- 1. Trout View Subdivision; KPB File 2022-127**

ITEM 1 – TROUT VIEW SUBDIVISION

KPB File No.	2022-127
Plat Committee Meeting:	April 24, 2023
Applicant / Owner:	Alaska Mental Health Trust Authority of Anchorage, AK
Surveyor:	Taylor Moore / Kuna Engineering
General Location:	Browns Lake Road, Funny River, Funny River APC

STAFF REPORT

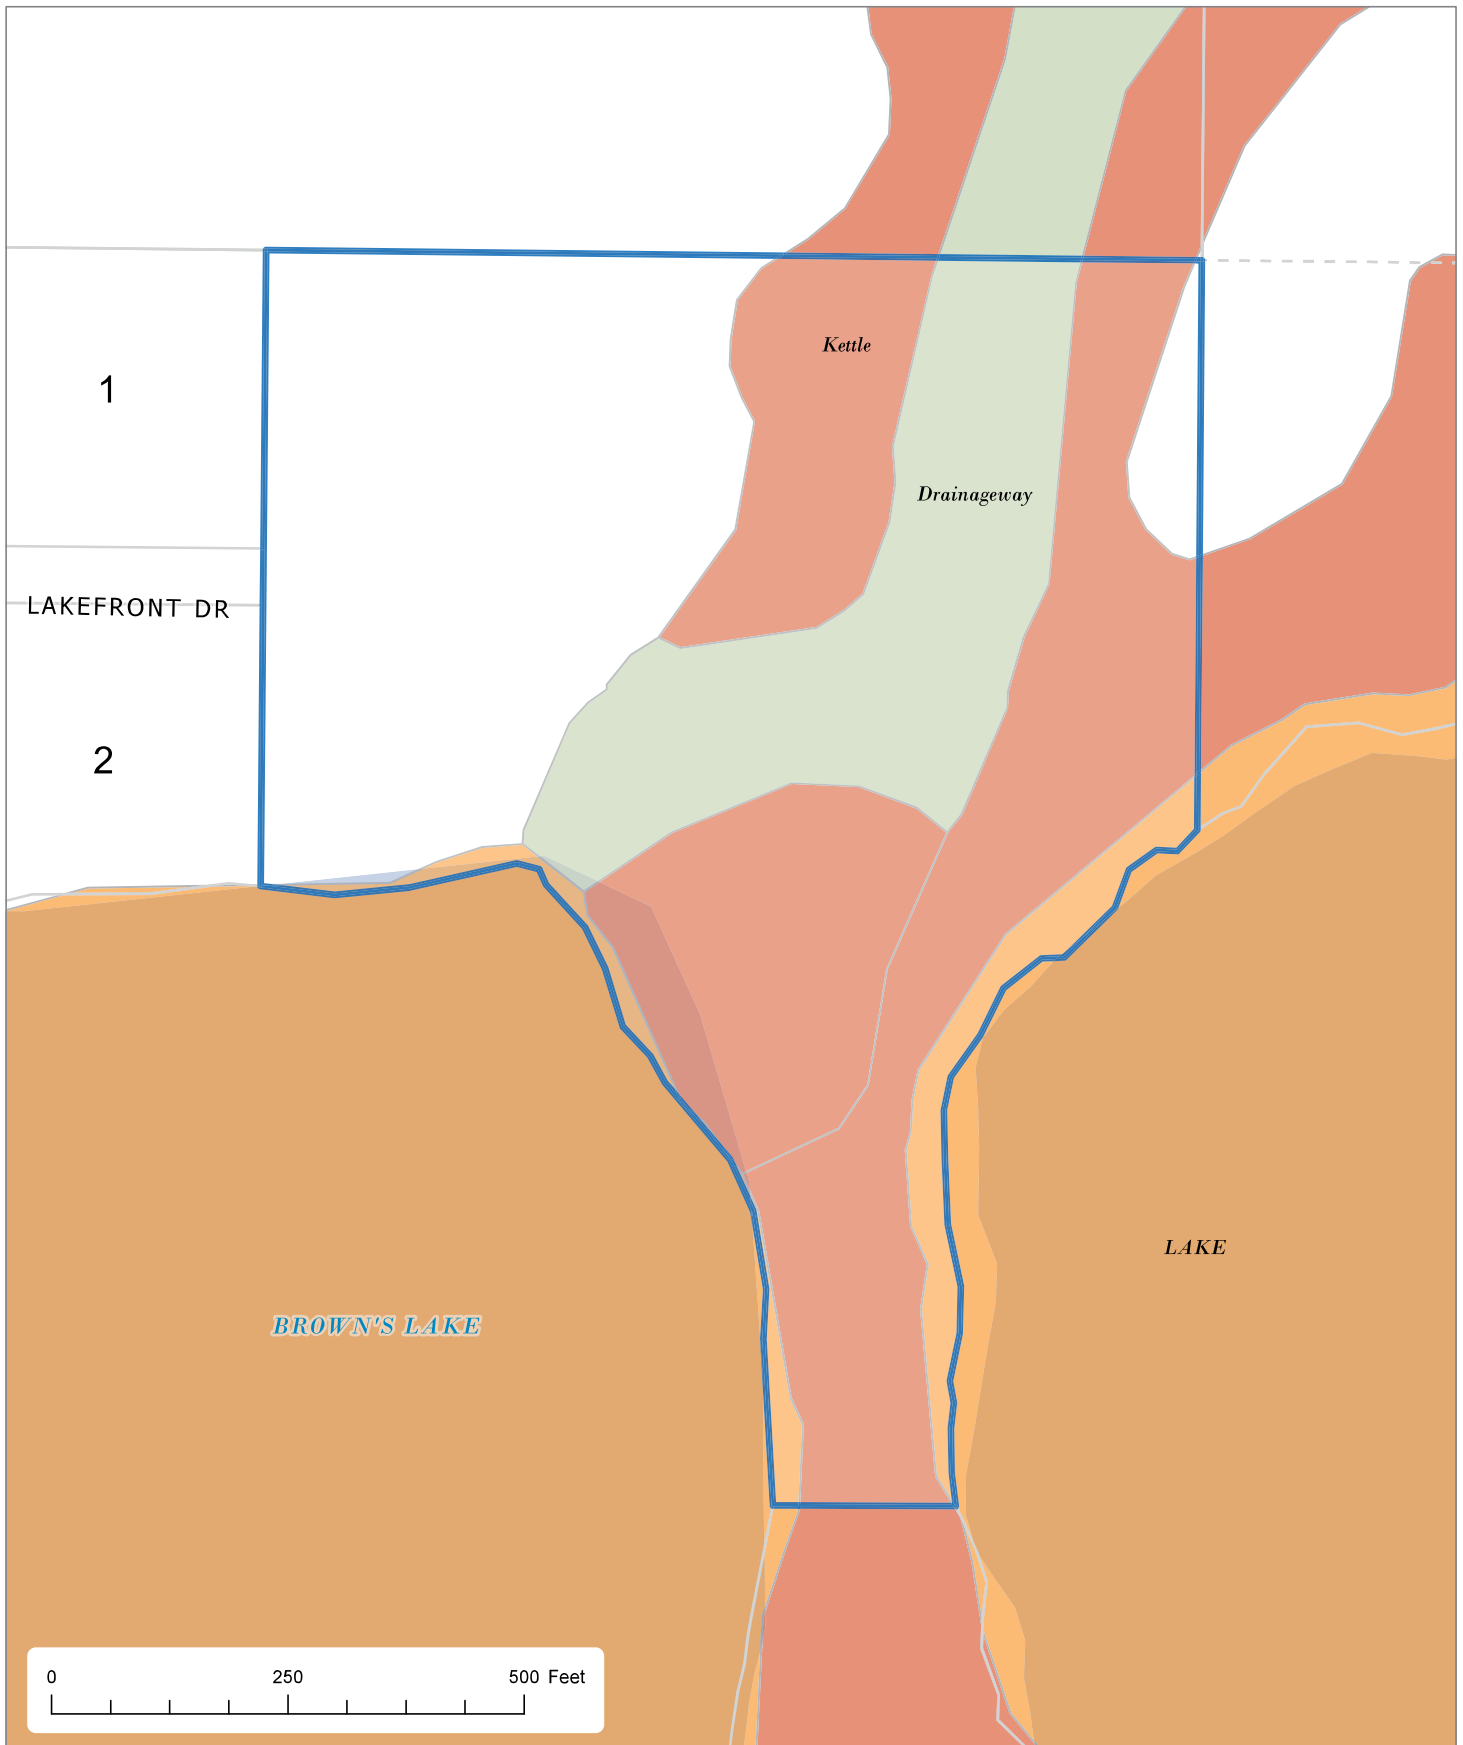
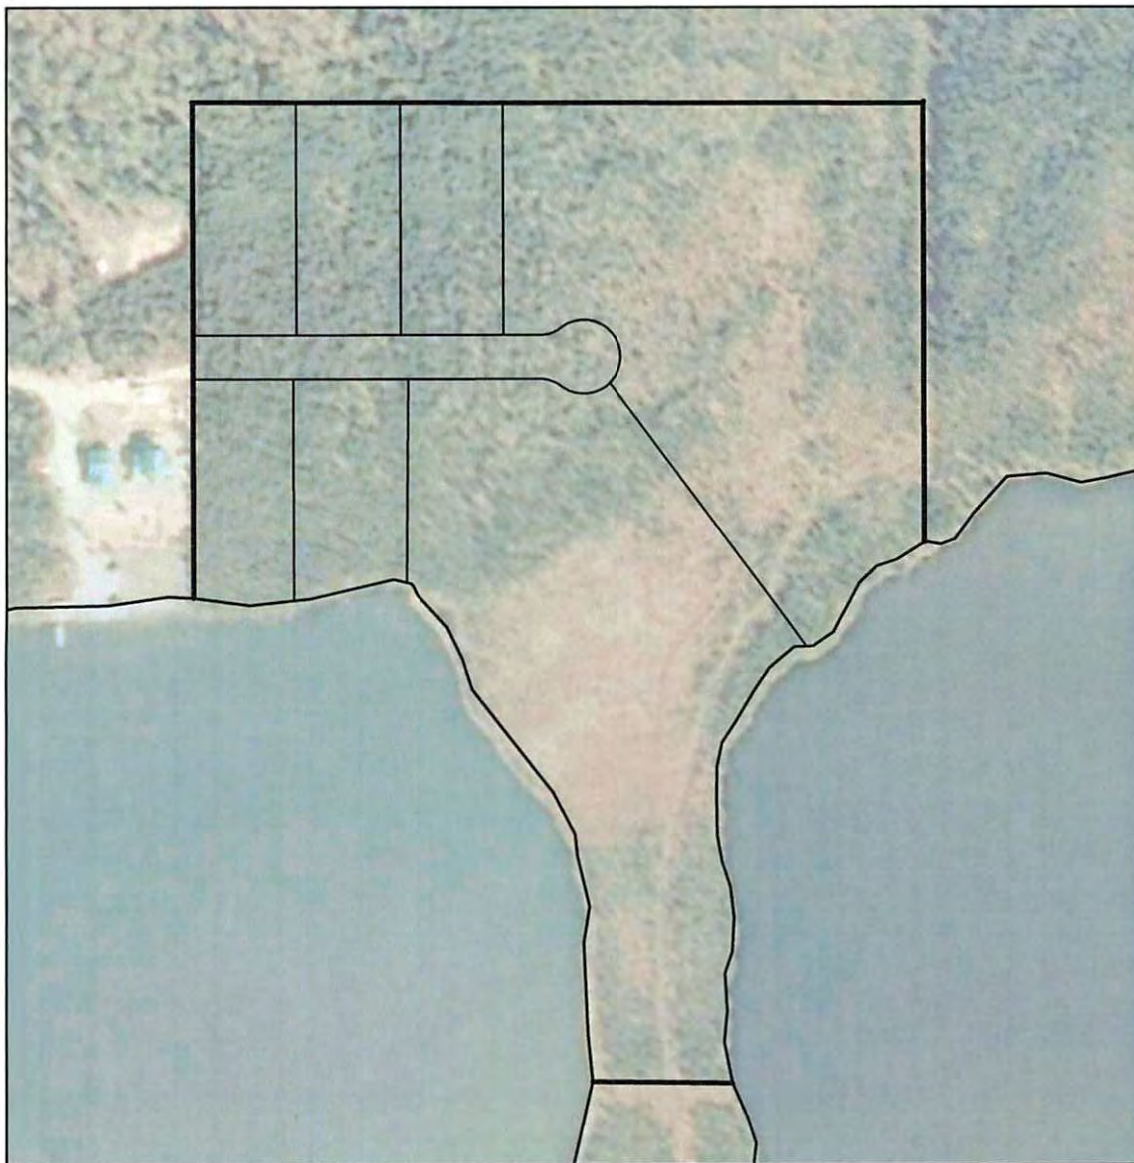
The legend will need to be reviewed to make sure the correct labels are present for what is being depicted. Make the legend stand out more.

The final plat will only be required to contain the acreage for each lot. The square footage labels may be removed. The two lots with wetlands should have their overall acreage listed and the upland acreage listed instead of listing it as developable space.

- *The owner's information is required within the title block, this includes their mailing address.*
- *Update the spelling of "Kenai" in the recording district information.*
- *Provide within the title block or near it the KPB File number of 2022-127.*
- *Provide an aliquot location with the located within information, "SE1/4 SE1/4".*

Staff recommendation: *Verify the section line easements within and abutting the subdivision. KPB data indicates that they may be subject to 50 foot wide easements. Provide documentation to show if not 50 feet. Label all section lines as such if they are depicted even if outside the bounds of the subdivision and adjust the line style as the ones to the south appear to be proposed parcel boundary.*

Staff recommendation: *Shade the plat in fully so that it stands out better. Provide a few labels for the major roads in the area such as Browns Lake Road and Lake Road.*

Staff recommendation: *Ownership is not recommended for the final as ownership changes. On the final remove reference to CIRI. The lots north of the unnamed lake and east of the subdivision should be labeled as Government Lot 9 and Government Lot 8 north of it. The lot south of proposed Lot 7 should be labeled as Government Lot 1.*

- M. Approximate locations of slopes over 20 percent in grade and if contours are shown, the areas of the contours that exceed 20 percent grade shall be clearly labeled as such;
Staff recommendation: *Stated was included but did not see with submittal. Some areas may be near the 20 percent grade in the northwest corner. Top and toe of bank need to be shown on the drawing.*

Staff recommendation: Verify that fonts are compliant and adjust a few to make sure all are clearly legible and no overstrikes. Comply with 20.60.070.

- *Update the certificate of ownership to be in the singular and on behalf of Alaska Mental Health Trust Authority. "I hereby certify that Alaska Mental Health Trust Authority is the owner of the real property shown and described hereon and that I hereby adopt this plan of subdivision on behalf of Alaska Mental Health Trust Authority..."*
- *Update the owner on the certificate of ownership information from Health Trust Land Office to Health Trust Authority.*
- *Update the year on the Notary's Acknowledgment.*
- *Update the surveyor's certificate as some information states N/A.*
- *Comply with 20.60.190.*
